NO.	DESCRIPTION	DATE
1	ISSUED FOR PERMIT	06-07-19
2	PERMIT / OWNER REV.	09-19-19
3	OWNER REVISION / VE	10-04-19
4	MARKETING & COORDINATION	11-05-19
5	PRECAST UNIT REVISIONS	02-03-20
6	ELEV. MANUF. UPDATES	03-19-20
7	TYPEK DETAILS - R1#1	05-08-20
8	EXTERIOR LIGHTING UPDATE	07-31-20
9	WALKROOM DETAILS	08-20-20
10	OWNER DEN ENCLOSURE	09-17-20
11	COMBO UNIT REVISION #1	10-09-20

A101.2

CASE #PL2020-227

1 FIRST FLOOR PLAN - EAST
SCALE: 1/8"=1'-0"

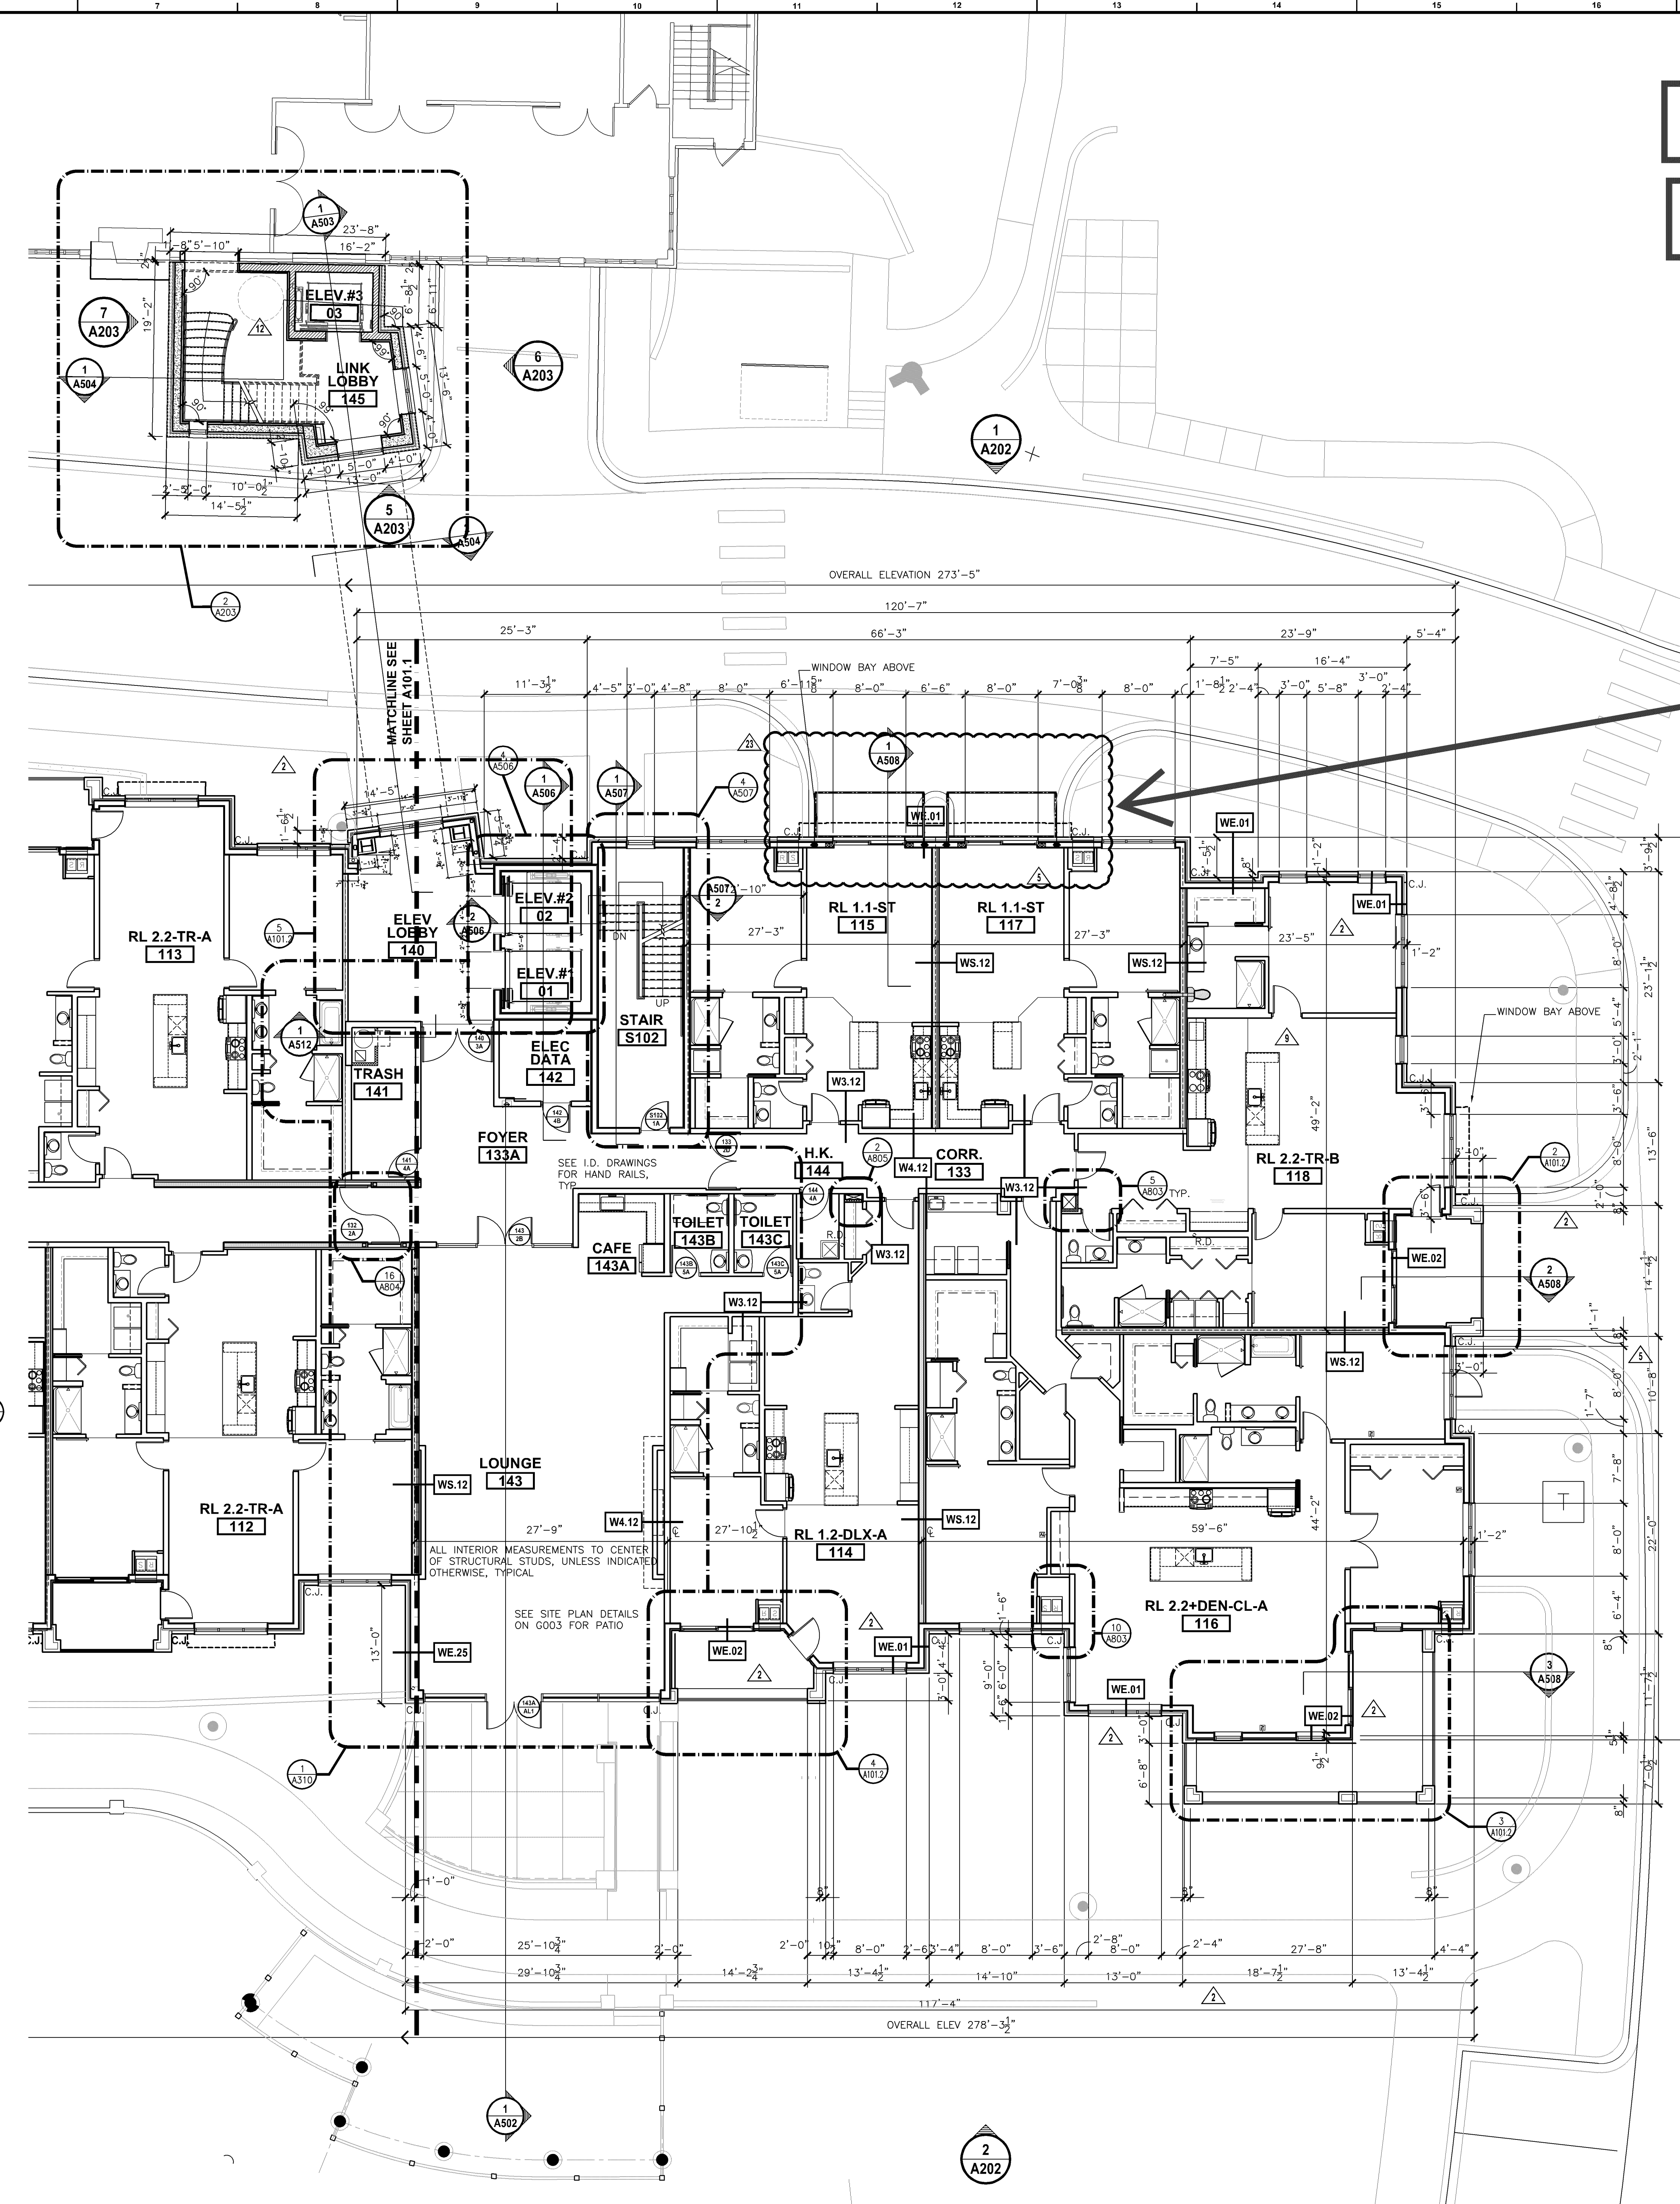
(2) ADDED BALCONIES

1 THIRD FLOOR PLAN - EAST
SCALE: 1/8"=1'-0"

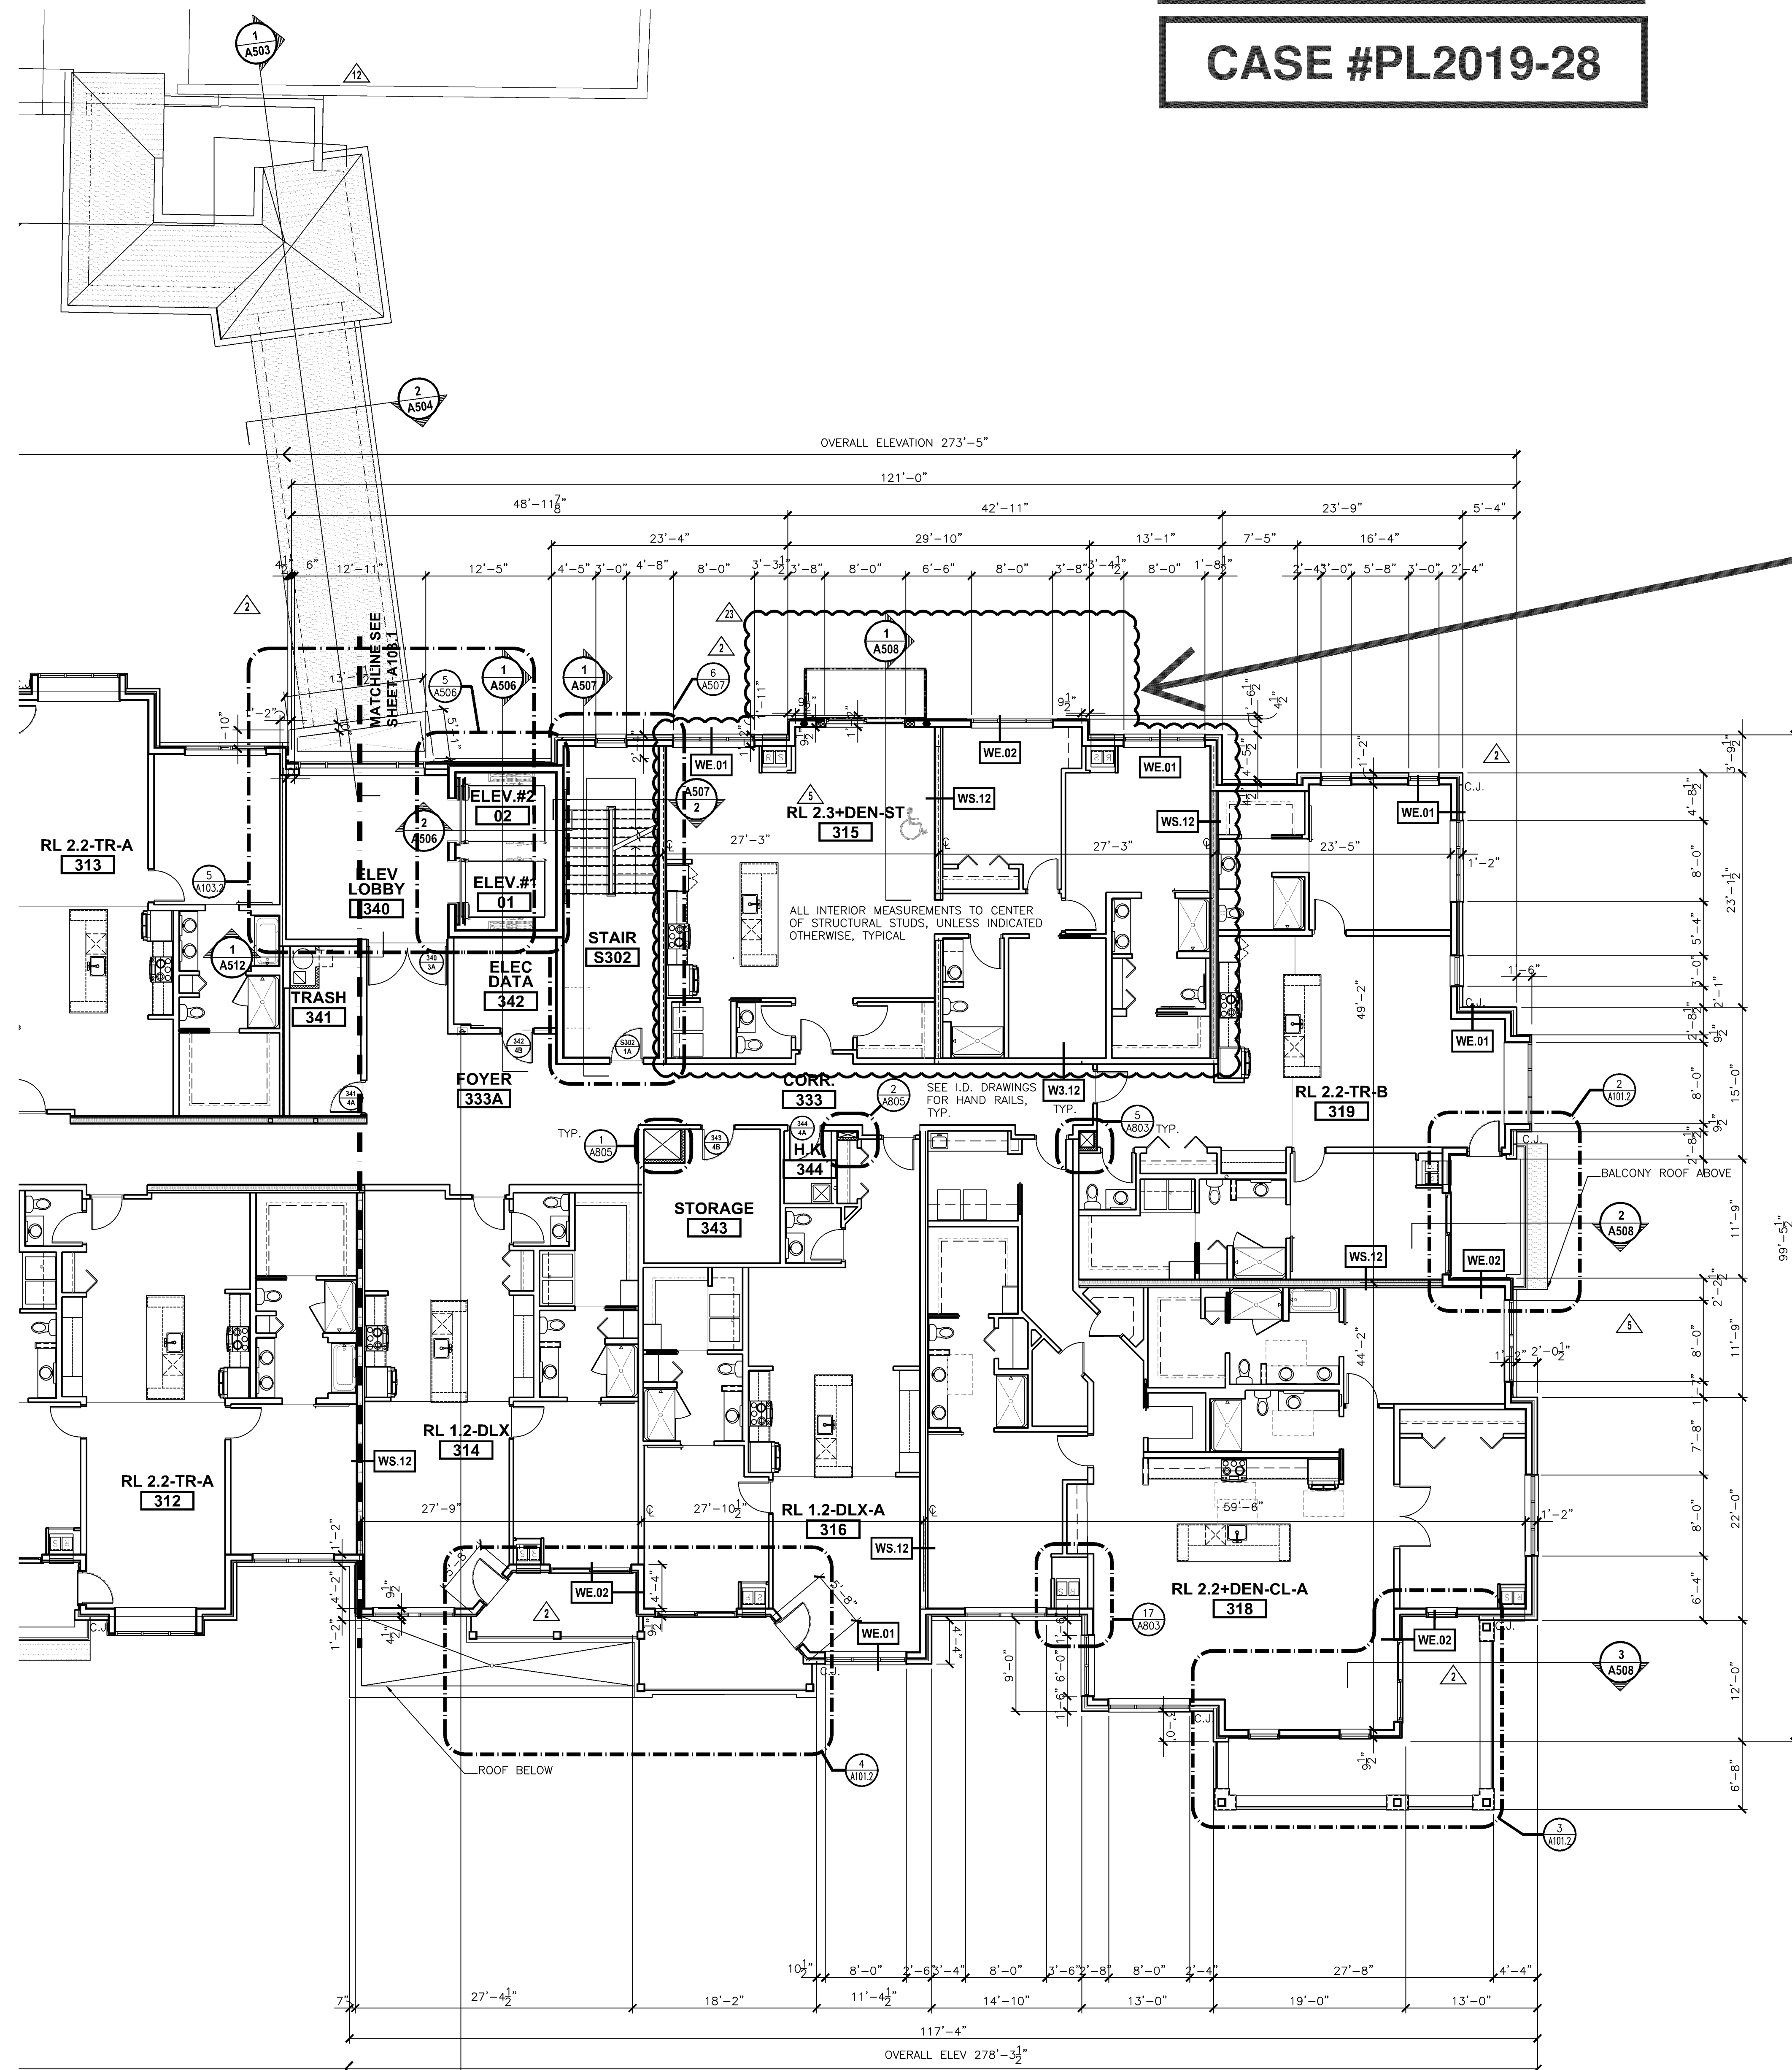
(1) ADDED BALCONY,
COMBINED (2) UNITS
INTO A SINGLE UNIT

1 FOURTH FLOOR PLAN - EAST
SCALE: 1/8"=1'-0"

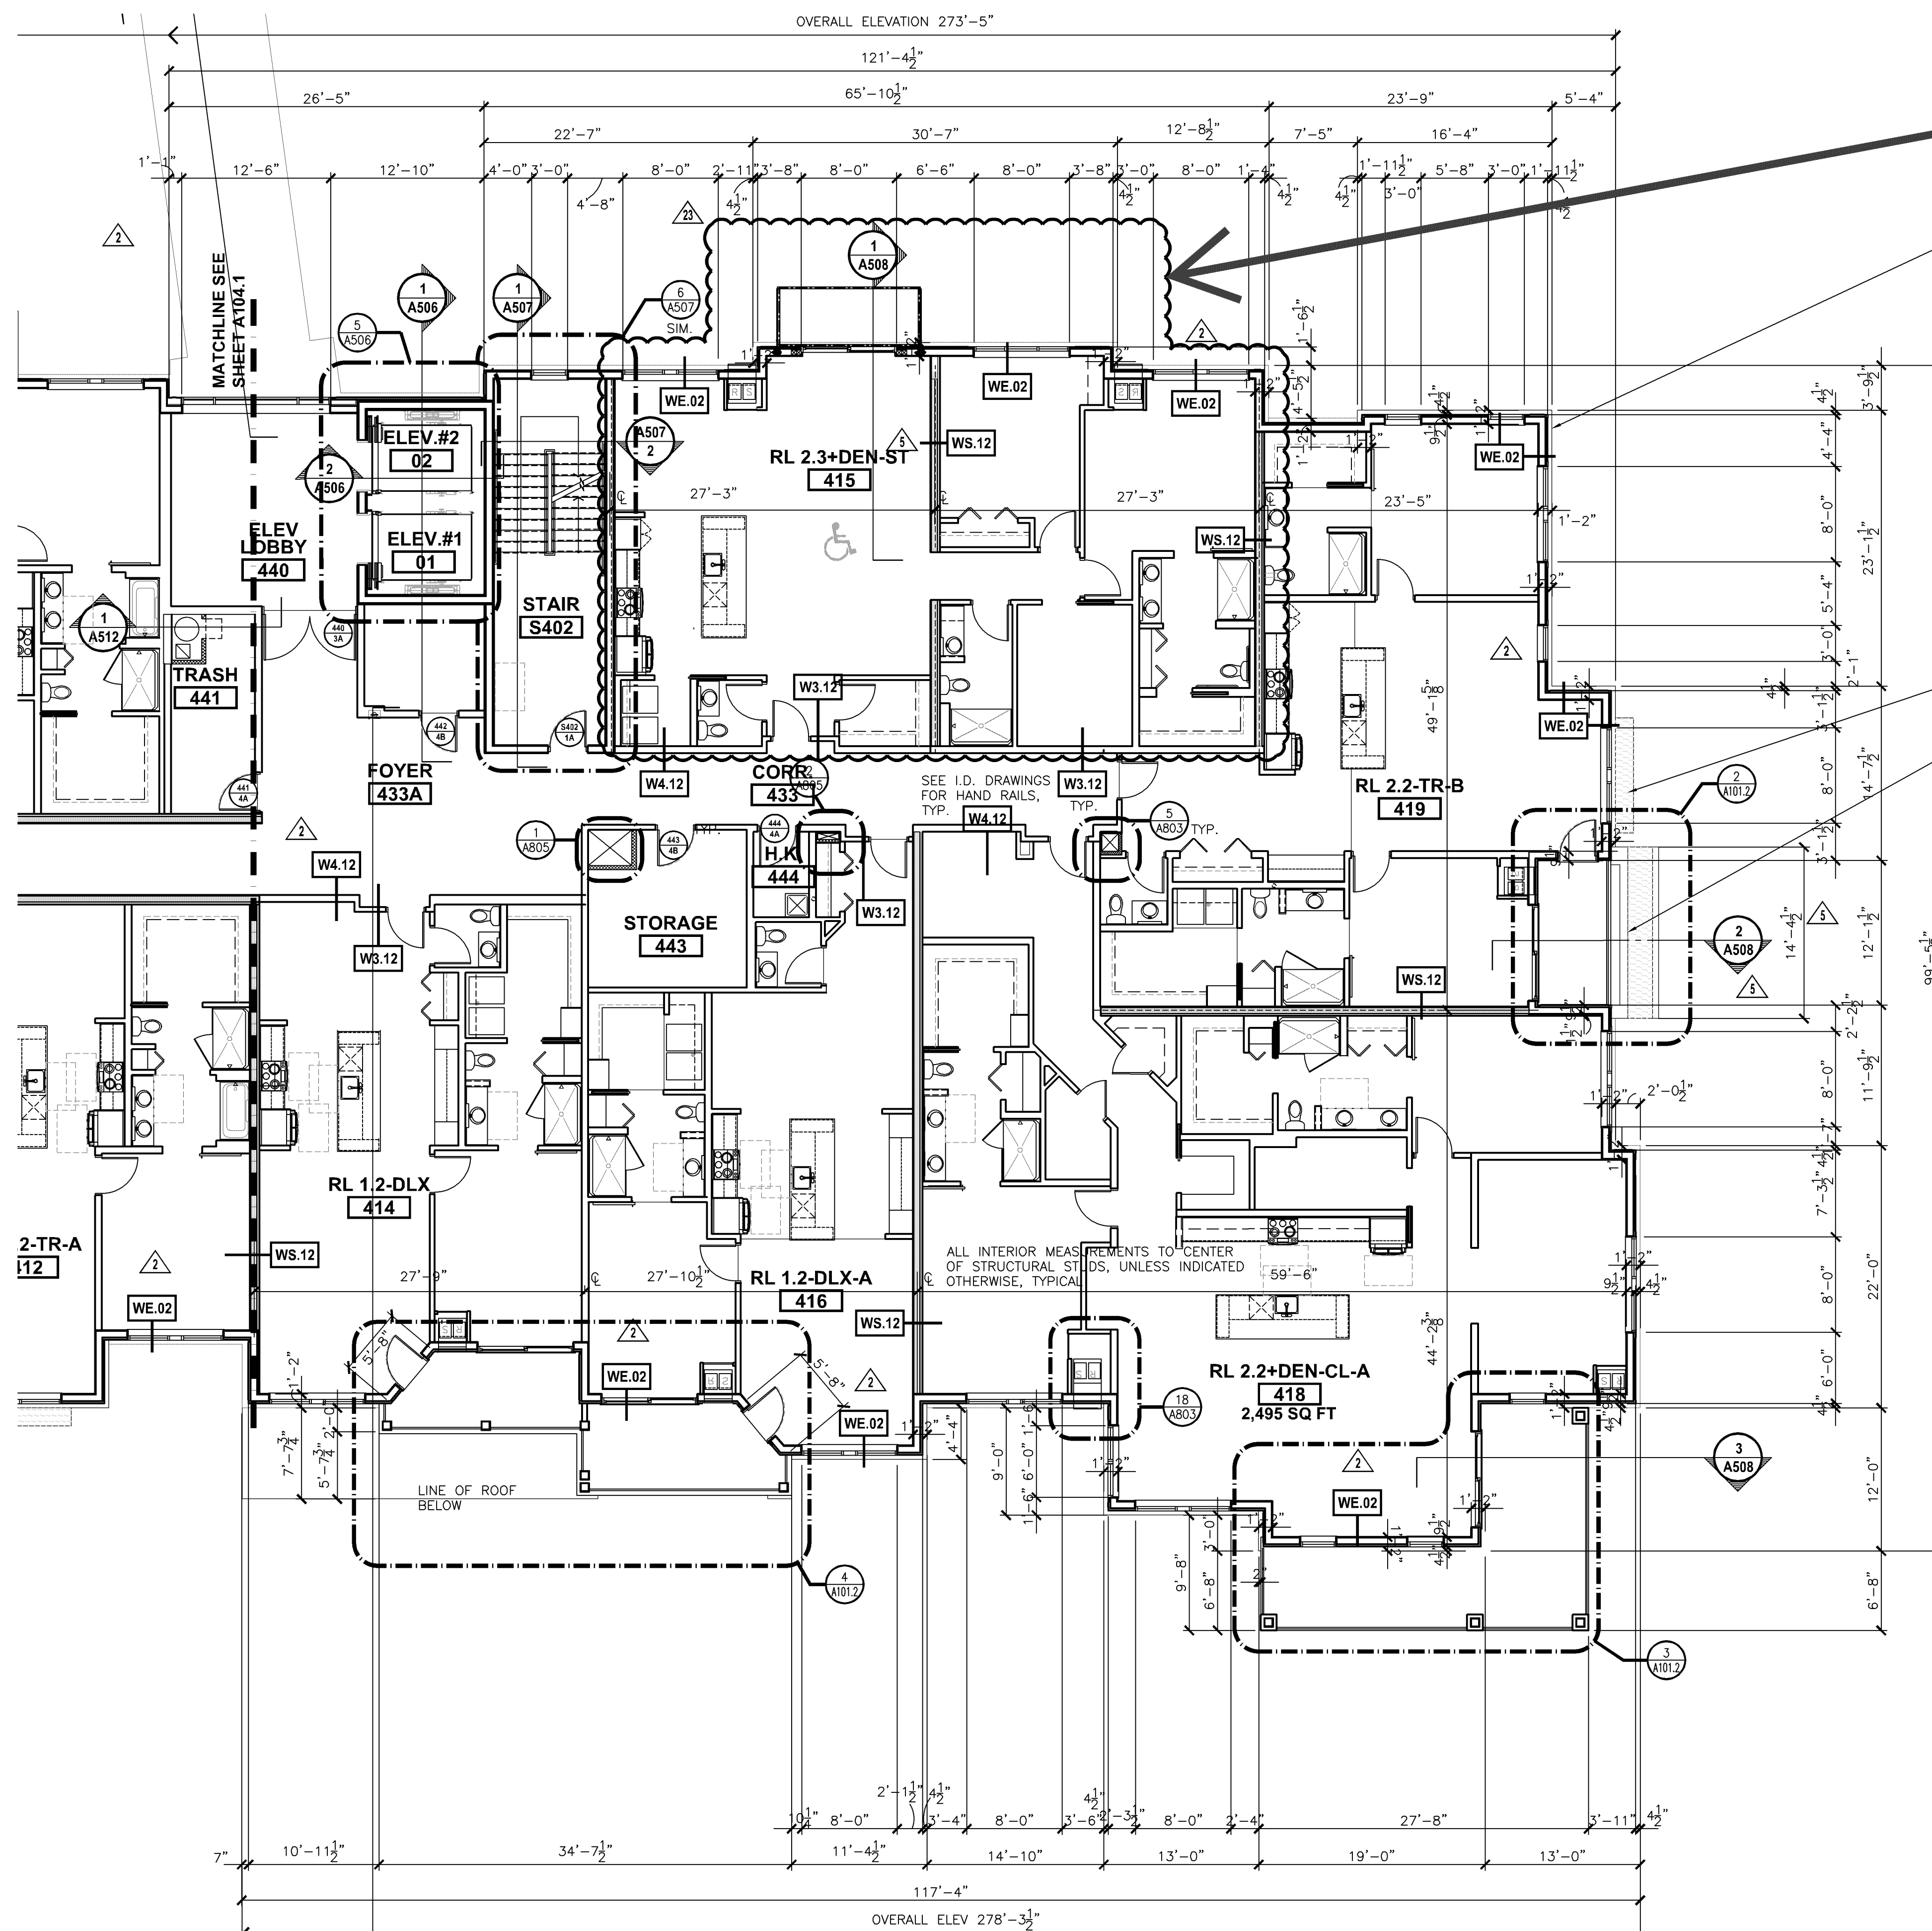
(1) ADDED BALCONY, COMBINED (2) UNITS INTO A SINGLE UNIT
